Re: Proposed Convenience Store – Washington Street

File: 2014-033E

We have reviewed your correspondence dated October 27, 2014 and offer the following responses. Our responses correspond to your comments and are shown in bold. We have attached the following drawings for review at the 7 April 2015 Planning Board meeting:

VALENTINE STORES, INC.
NICE AND EASY CONVENIENCE STORE

SITE AND LANDSCAPING PLAN

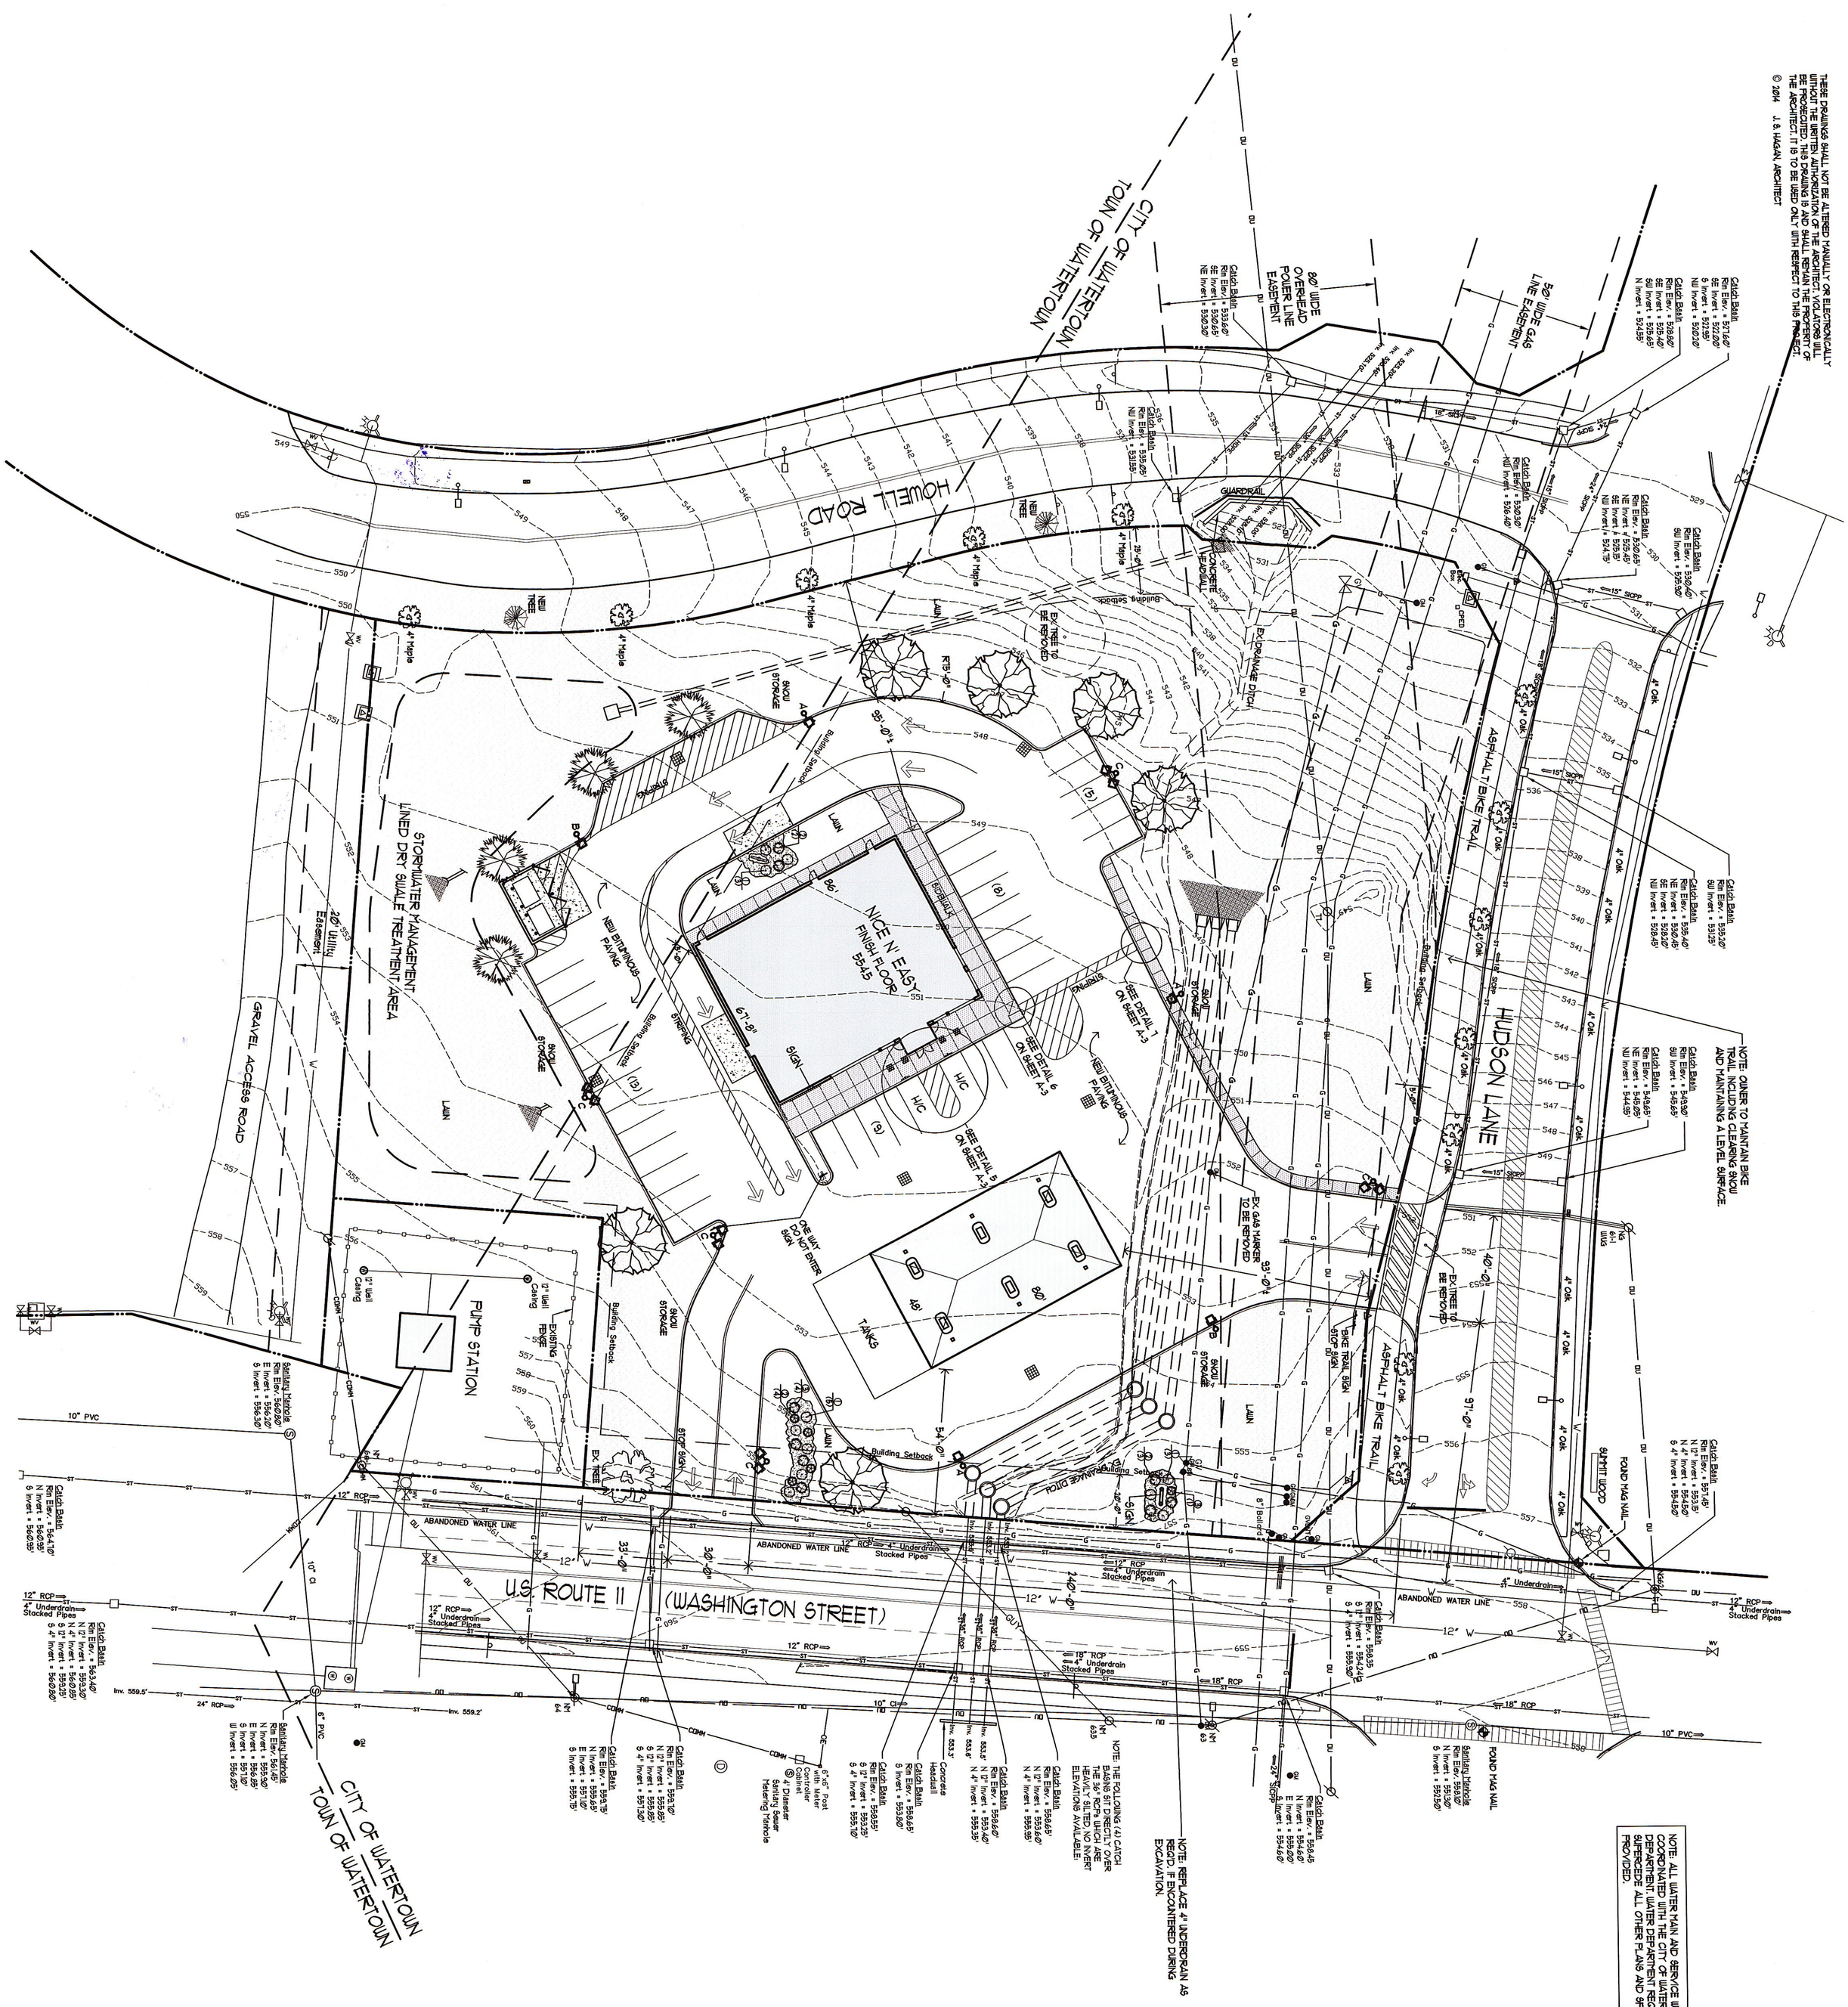
1. The applicant shall label all curb radii.

4. The applicant shall provide striping and flow arrows for Hudson Lane, and depict additional detail on its curb tie-in on the grading plan.

19. Two large maturing street trees spaced 40' on center, along with planting beds, shall be added along Washington Street north of the entrance/exit area and four large maturing street trees spaced 40' on center shall be added on the northwest side of the site, starting at the City boundary and ending just before the electric easement.

20. Two 2" diameter, large maturing street trees shall be planted in the Howell Road right-of-way, spaced evenly in between the existing trees, as replacements for the City tree that is required to be moved.

21. Planting beds shall be added around the sign, at the entrance/exit areas and along the rear of the building.

22. The applicant shall provide a separate Landscaping Plan that calls out all tree removals, and includes a planting schedule with species and size information.

27. Snow storage areas shall be delineated.

Agreed. Refer to JS Hagan Site and Landscaping Plan.

Agreed. Refer to JS Hagan Site and Landscaping Plan.

Agreed. Refer to JS Hagan Site and Landscaping Plan.

Agreed. Refer to JS Hagan Site and Landscaping Plan.

Agreed. Refer to JS Hagan Site and Landscaping Plan.

Agreed. Refer to JS Hagan Site and Landscaping Plan.

Agreed. Refer to JS Hagan Site and Landscaping Plan.

ONE WAY SIGN DETAIL (8)

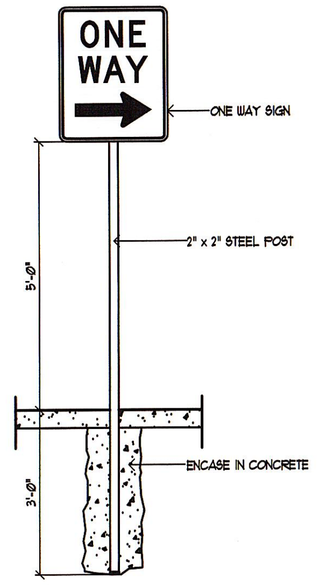
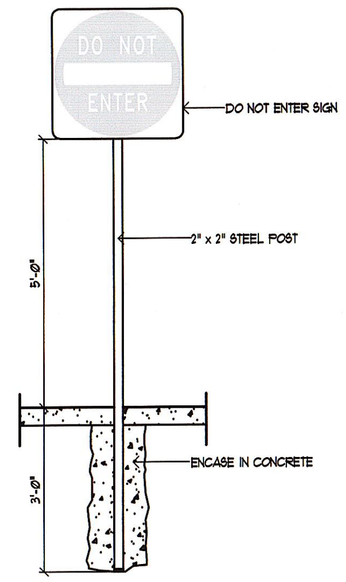
- One Way, Do Not Enter Sign Details

Agreed. Refer to JS Hagan details.

GREASE TRAP DETAIL (1000 GAL) (22)

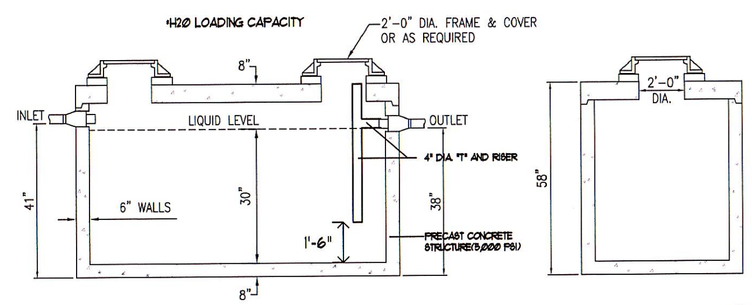
- Cut sheet and design of the proposed grease trap

Agreed. Refer to JS Hagan details.

LIGHT POLE BASE DETAIL (1)

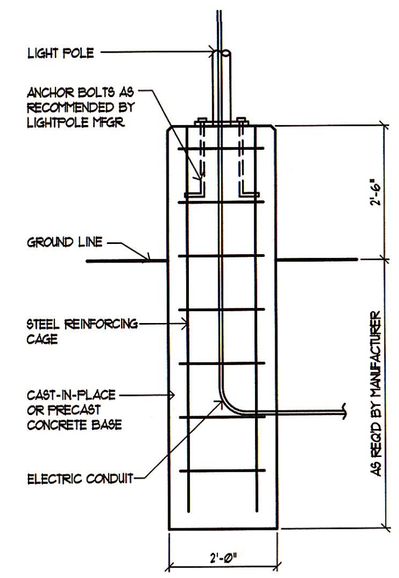
- Lightpole Detail

Agreed. Refer to JS Hagan details.

CURB DROP FOR WHEELCHAIR ACCESS (6)

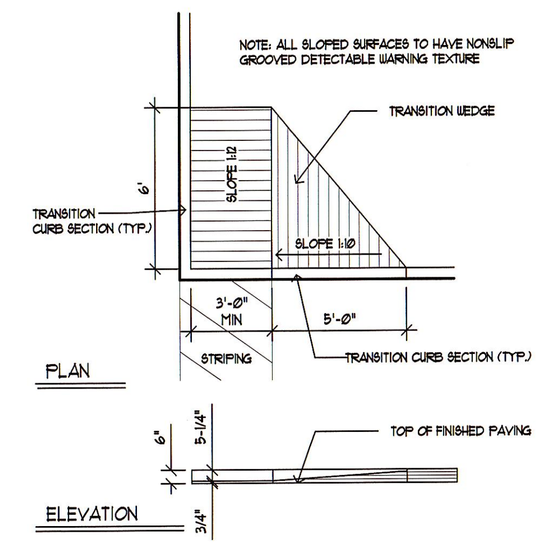
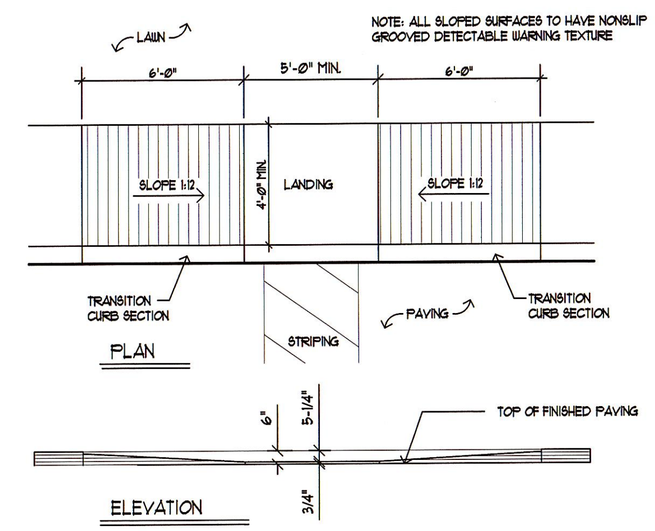
- Detail of Sidewalk Ramp

Agreed. Refer to JS Hagan details.

CITY R.O.W. CONCRETE CURB/SIDEWALK/PAVEMENT DETAIL (4)

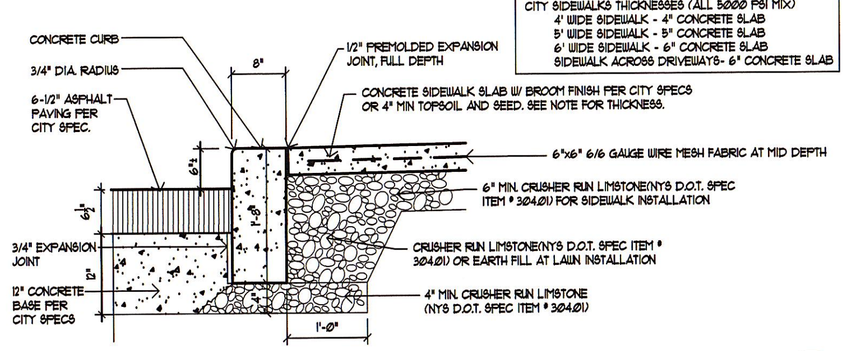
- City Sidewalk Detail

- Detail of curb within City R.O.W.

- Asphalt Pavement Section Detail for areas within the City R.O.W. & concrete road repair.

Agreed. Refer to JS Hagan details.

Agreed. Refer to JS Hagan details.

Agreed. Refer to JS Hagan details.

ON-SITE ASPHALT PAVING & CONCRETE SIDEWALK DETAIL (2)

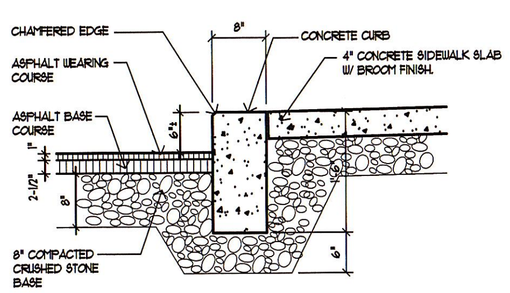
- Asphalt Pavement Section Detail for the proposed parking lot

Agreed. Refer to JS Hagan details.

ON-SITE CONCRETE CURB & LAWN AREA DETAIL (3)

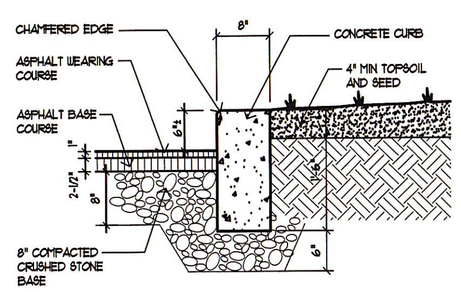
- Detail of typical lawn area installation

Agreed. Refer to JS Hagan details.

7	TYPICAL STORM OUTFALL DETAIL
C501	NOT TO SCALE D114-02

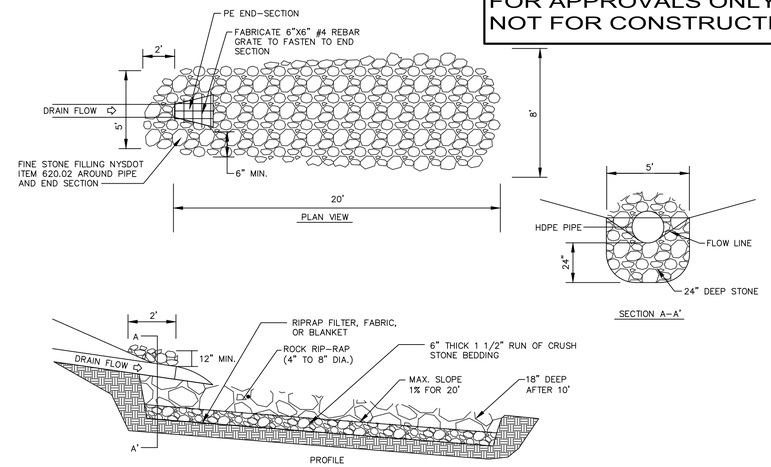
- Indicate where the applicant is proposing the riprap slope detail vs. the flared end section detail. Also, there are differing end section details in the Jim Hagan and GYMO plans. Delete the unused details.

Agreed. Slope protection via rip-rap is not anticipated for the project, and the rip rap slope detail has been removed. Rip-rap is proposed at culvert/storm pipe end

sections. Refer to the GYMO Utility and ESC Plan and Details sheet C501.

1	DRY SWALE DETAIL
C501	NOT TO SCALE

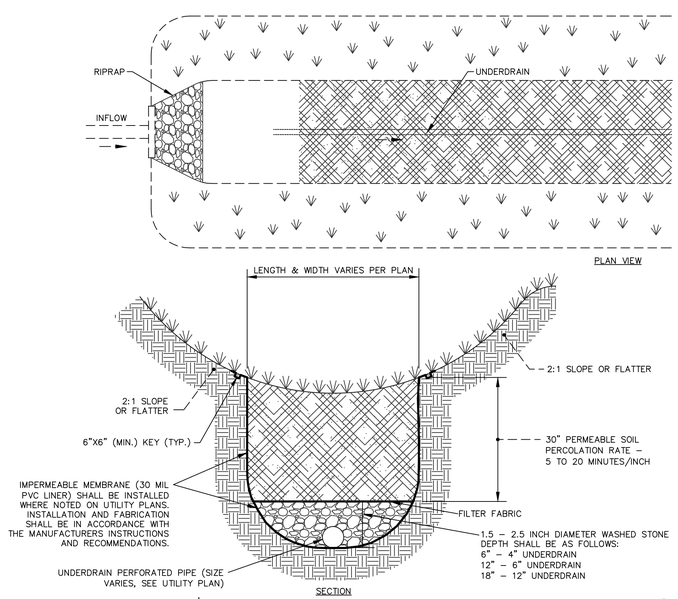
- Stormwater Pond and Profile

Agreed. Refer to GYMO Details sheet C501 and C502 for the storm water management area (dry swale) which includes, plan and cross section views

of the swale.

2	TYPICAL PRECAST CATCH BASIN DETAIL
C502	NOT TO SCALE D102-03

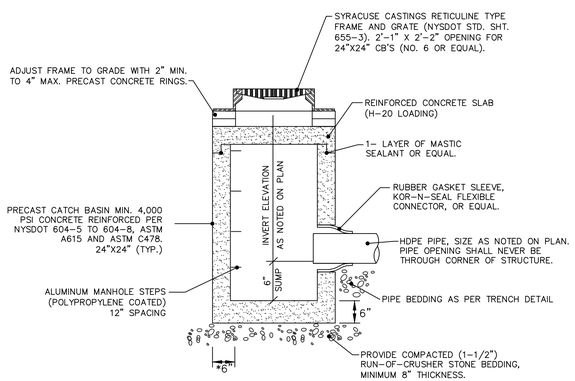
- A standard catch basin detail is included in both sets of plans. Only one catch basin detail should be included in the set.

Agreed. Refer to revised GYMO Details sheet C502.

1	PUMPING STATION DETAIL
C503	NOT TO SCALE

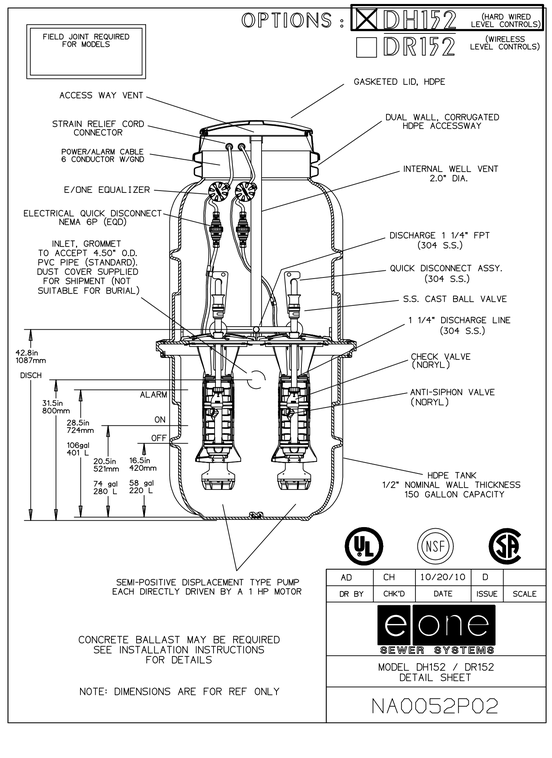
- Pump station schedule

Agreed. Refer to GYMO Details sheet C503.
